# Access Compliance Report

### (Curb Ramps)

Intersection ID: 3706	Main Street: PROSPERITY_CHURCH_RD	Cross Street: PROSPERITY_POINT_LN	Location: W
ADA ID: 6BC6472AE788	Ramp Type: Perp	Initial Pass/Fail: Fail	Overall Compliance: No
Severity Score: 1.25			
Codes/Mitigation Info/Possible Solution		Field Measurements/Component Compliance

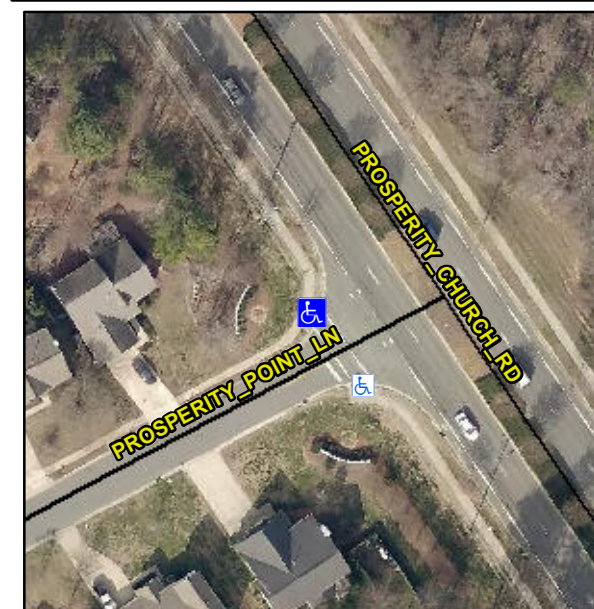
**R304.5.3**

Compliance	Description	Data	Compliance	Description	Data
N/A	Ramp Length (in)	39.5	Yes	Ramp Slope (%)	7.7
Yes	Ramp Width (in)	51.5	No	Ramp XSlope (%)	3.5
N/A	Flare Type LT	N/A	N/A	Flare Type RT	N/A
N/A	Flare Slope LT (%)	N/A	N/A	Flare Slope RT (%)	N/A
N/A	Flare Traversable LT?	N/A	N/A	Flare Traversable RT?	N/A
N/A	Landing Length (in)	N/A	N/A	DWS Provided?	N/A
N/A	Landing Width (in)	N/A	N/A	DWS Contrast?	N/A
N/A	Landing Slope (%)	N/A	N/A	DWS Length (in)	N/A
N/A	Landing X Slope (%)	N/A	N/A	DWS Full Width?	N/A
N/A	Landing Curb? (Y/N)	N/A	N/A	DWS Offset (in)	N/A
N/A	Shared Landing?	N/A			
N/A	Gutter Ponding?	N/A	N/A	Gutter Slope (%)	N/A
N/A	Gutter Lip Ht (in)	N/A	N/A	Gutter X Slope (%)	N/A
N/A	Painted X Walk1?	Yes	N/A	Painted X Walk2?	N/A
	X Walk 1 Direction	To SE		X Walk 2 Direction	N/A
N/A	X Walk 1 Width (in)	120.0	N/A	X Walk 2 Width (in)	N/A
	X Walk 1 Slope (%)	1.3		X Walk 2 Slope (%)	N/A
	X Walk 1 X Slope (%)	4.0		X Walk 2 X Slope (%)	N/A

**Remove & Replace Entire Ramp.**
